STAFF REPORT
COMMUNITY DEVELOPMENT DEPARTMENT

HEARING DATE: January 6, 2022
 DATE: *Continued from: December 2, 2021*

SUBJECT: H-2021-0075
 Rackham East – AZ, PP
 Eagle View Apartments – CUP, ALT

C. Landscape Plan – Preliminary Plat (date: 10/15/2021)

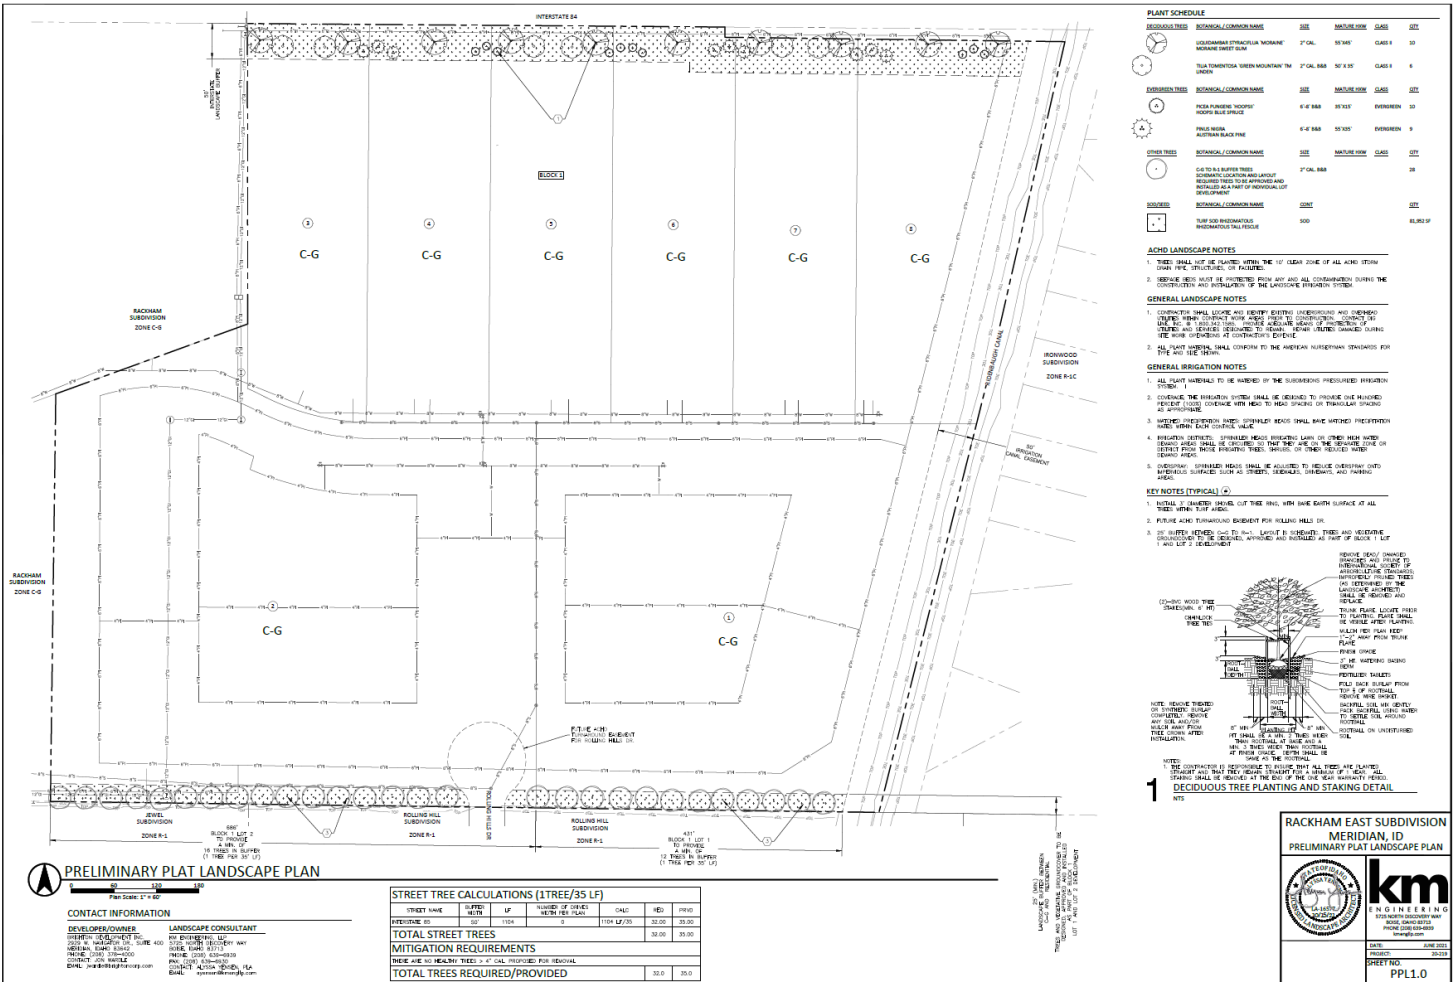
A 50-foot wide street buffer is required on Lots 3-6 along the north boundary of the site adjacent to I-84 per UDC [Table 11-2B-3](#), landscaped per the standards listed in UDC [11-3B-7C](#). The buffer depicted on the landscape plan complies with this standard. The street buffer is required to be maintained by the property owner or business owners' association per UDC [11-3B-7C.2b](#) and should be depicted on the plat in a common lot or permanent dedicated buffer.

Landscaping is required adjacent to the pathway proposed along the northern boundary of the site in accord with the standards listed in UDC [11-3B-12C](#). **A 5-foot wide landscape strip is required on both sides of the pathway planted with a mix of trees, shrubs, lawn and/or other vegetative ground cover.**

All fencing is required to comply with the standards listed in UDC 11-3A-7. Fencing is not depicted on the landscape plan; however, a 6-foot tall open vision wrought iron fence is proposed along the Ridenbaugh Canal to preserve public safety if Council approves a waiver to allow it to remain open and not be piped.

3. The landscape plan submitted with the final plat shall be revised as follows:
 - a. Depict a pathway within the street buffer along I-84 as shown on the CUP landscape plan with landscaping in accord with the standards listed in UDC 11-3B-12C. *A 5-foot wide landscape strip is required on both sides of the pathway planted with a mix of trees, shrubs, lawn and/or other vegetative ground cover.*

D. Conceptual Development Plan

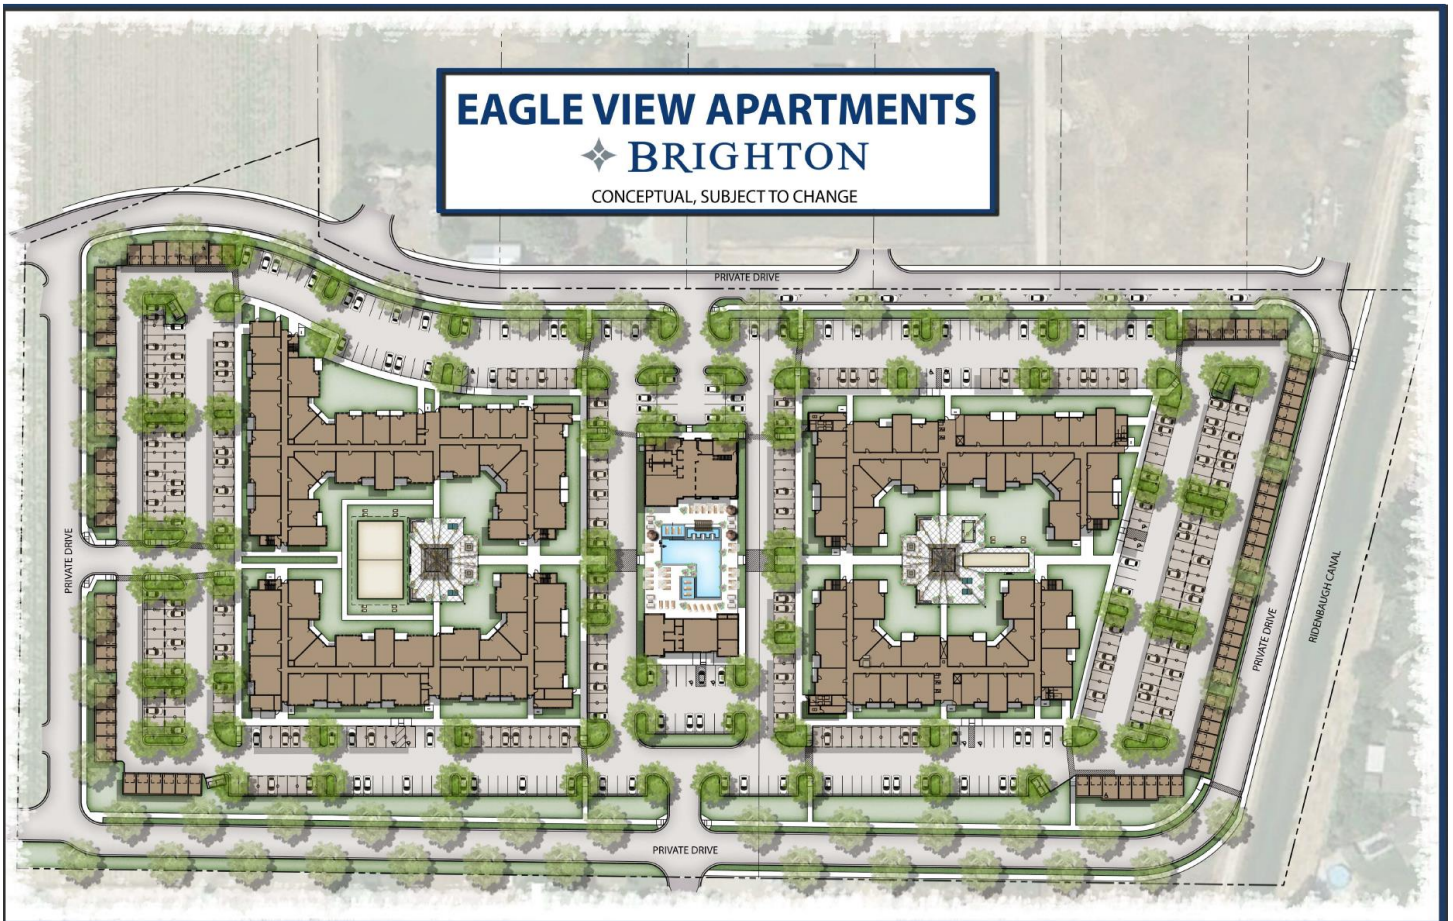
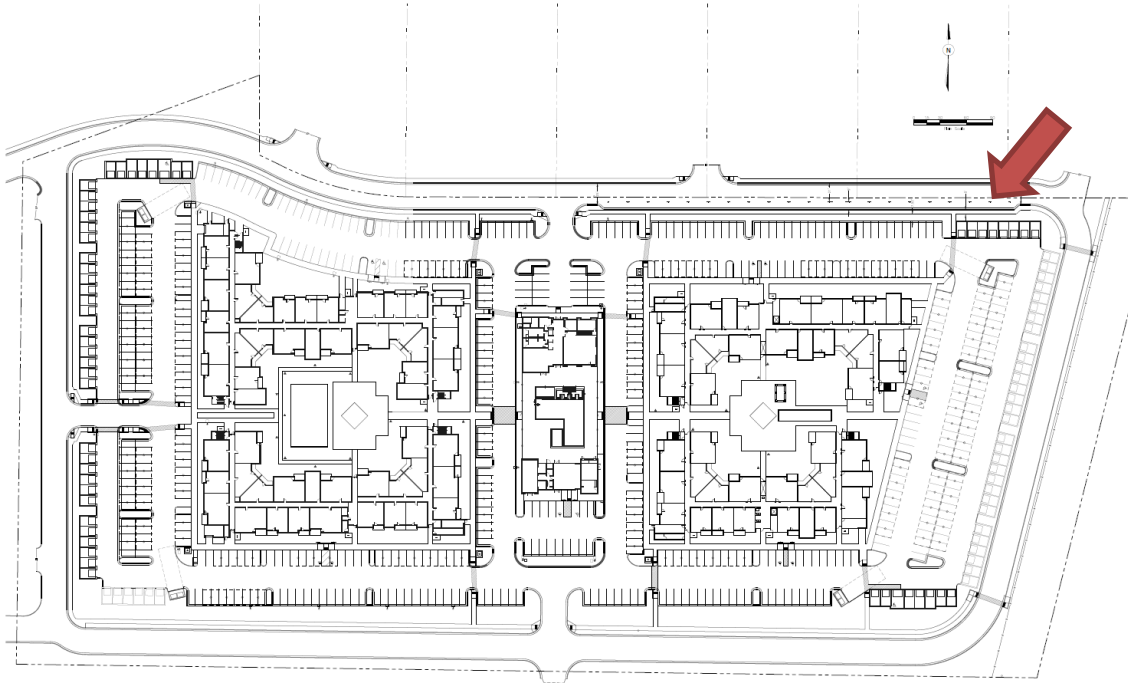
The conceptual development plan depicts a common area between the two office buildings that appears to meet this guideline; more details should be submitted on a site plan submitted for development of these buildings that comply with this guideline.

An outdoor gathering area is depicted on the conceptual development plan between the two office buildings on the northern portion of the site. Details should be submitted with development of these buildings that demonstrate compliance with this guideline.

The proposed conceptual development plan depicts a plaza/gathering area between the two office buildings on the northern portion of the site. A pedestrian circulation network, which will connect to the larger 90-acre Eagle View/Rackham development to the west, is proposed around the perimeter of the overall development as well as throughout the site that provide pedestrian connections to the multi-family development, office, retail, restaurant and hospitality uses within the development.

- b. The two (2) office buildings proposed on the northern portion of the site shall be arranged to create some form of common, usable gathering area, such as a plaza or green space in accord with the mixed-use guidelines in the [Comprehensive Plan](#) (see pg. 3-13).

- c. Provide a pedestrian pathway within the street buffer along I-84 as depicted on the conceptual development plan with landscaping along the pathway as set forth in UDC [11-3B-12C](#). Also provide internal pedestrian walkways throughout the site for interconnectivity; where pedestrian walkways cross vehicular use areas they shall be distinguished through the use of pavers, colored or scored concrete, or bricks as set forth in UDC [11-3A-19B.4](#).

Updated Site Plan with on-drive aisle parking (1/3/22): (20 extra parallel parking spaces)

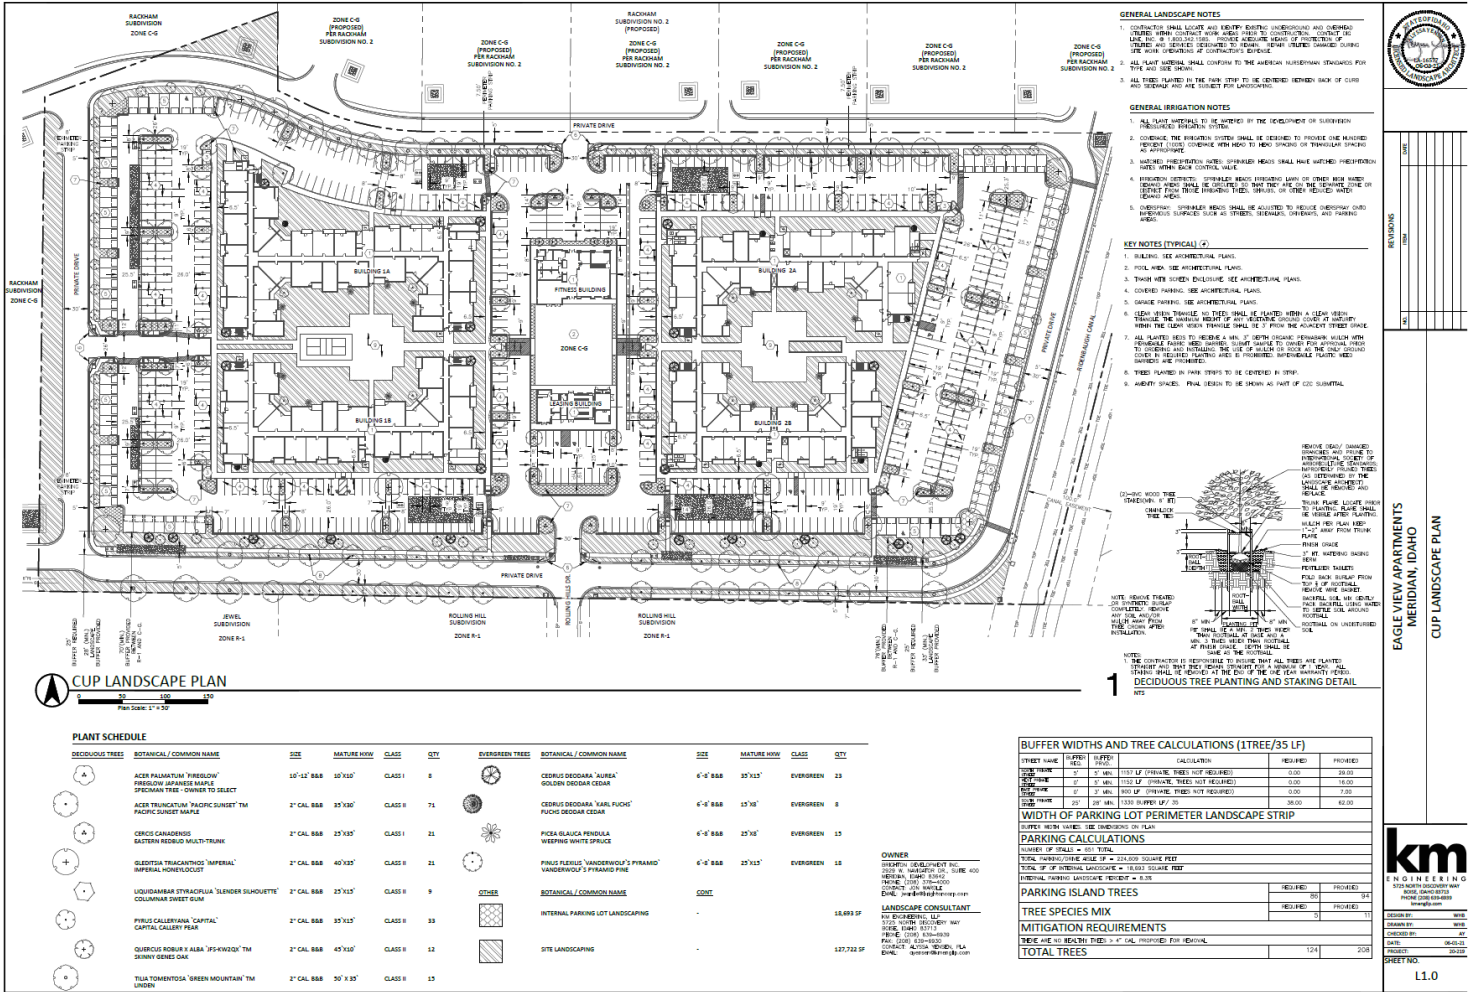
A total of ~~651~~ 649 spaces are proposed with 391 of those being covered in garages (88)/carports (303), which includes compact spaces; **compact stalls are discouraged but may be used for parking above the number of required parking spaces. Additional parking should be provided to meet the minimum standards; the site/landscape plan submitted with the Certificate of Zoning Compliance application should be revised to reflect compliance.** *Note: The calculations on the landscape plan state 651 spaces are proposed, which differs from that on the site plan.*

- j. Compact parking stalls are discouraged but may be used for parking *above* the number of required parking spaces per UDC [11-3C-5A.6](#). Based on the number of bedrooms per unit and square footage of the clubhouse proposed, a minimum of 660 standard off-street parking spaces are required with 348 of those being in a covered carport or garage. If these numbers/square footage change, parking may be adjusted accordingly to comply with applicable UDC standards.

F. Landscape Plan – Conditional Use Permit (dated: 6/3/21)

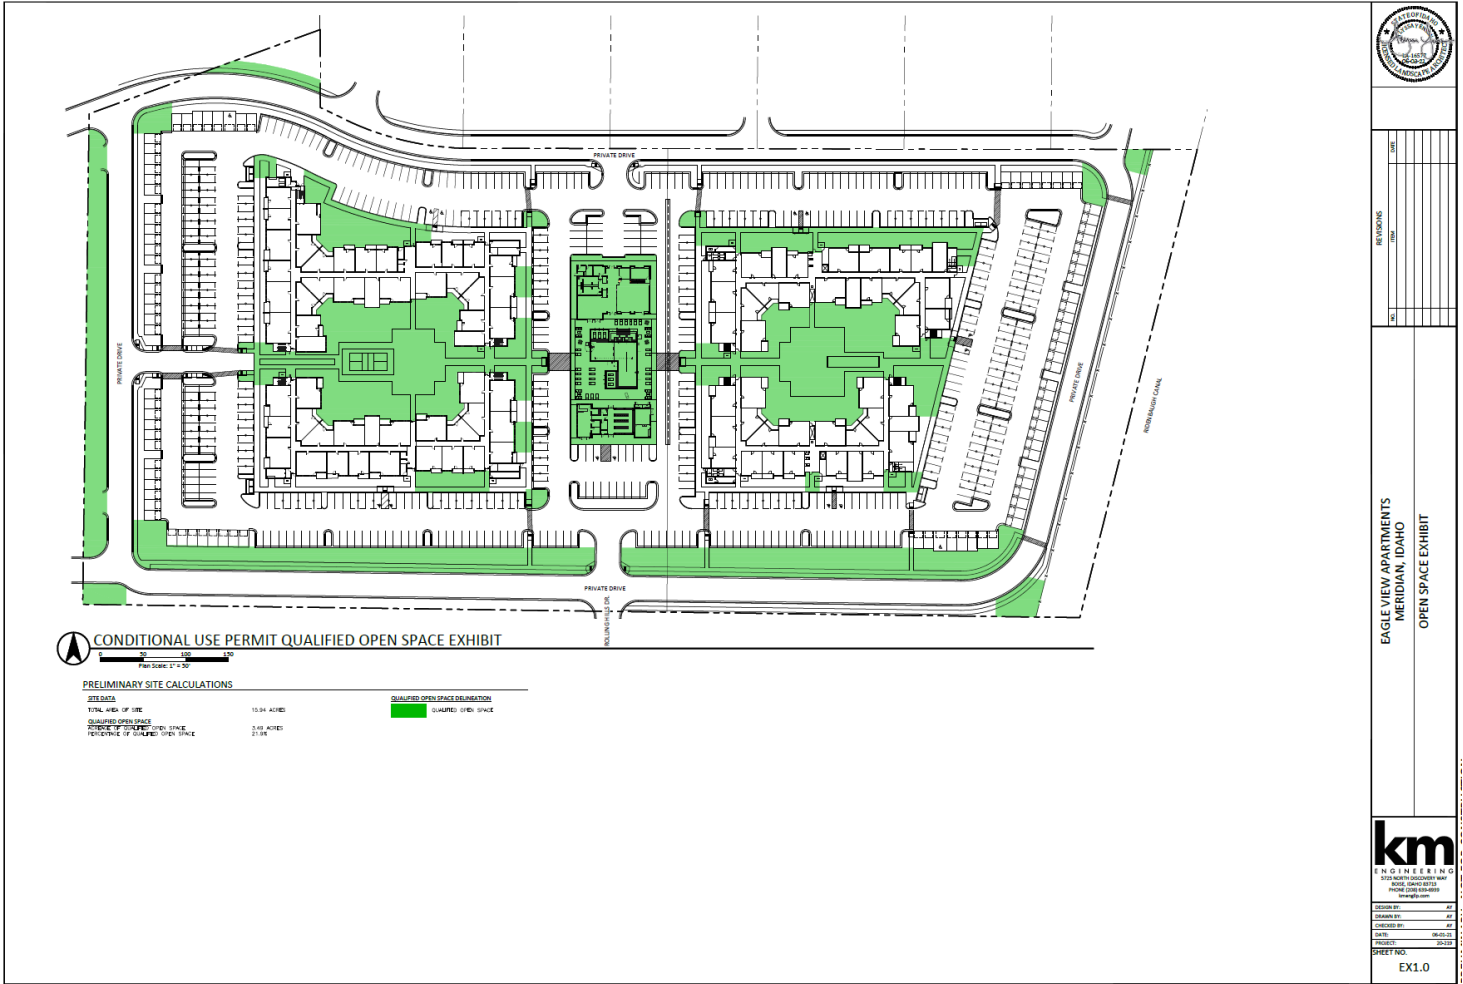
The landscape plan submitted with the Certificate of Zoning Compliance application should depict landscaping on all elevations facing the private drives in accord with these standards.

A minimum 25-foot wide buffer to residential uses is required with development along the southern boundary of the site per UDC Table 11-2B-3, landscaped per the standards in UDC 11-3B-9C, which requires a mix of evergreen and deciduous trees, shrubs, lawn, or other vegetative ground cover. **The buffer depicted on the landscape plan needs to be widened and additional landscaping depicted in accord with these standards.**

Fencing: No fencing is depicted on the landscape plan for this development. A 6-foot tall open vision wrought iron fence is proposed along the Ridenbaugh canal to preserve public safety if Council approves a waiver to allow the canal to remain open and not be piped.

As an added buffer to the two adjacent rural residential properties to the south in Rolling Hill Subdivision, Staff recommends a 6-foot tall sight obscuring fence or wall is constructed along the southern boundary of the site.

- e. Depict a 6-foot tall sight obscuring fence or wall along the southern boundary of the site as an added buffer to the rural residential properties to the south in Rolling Hill Subdivision.
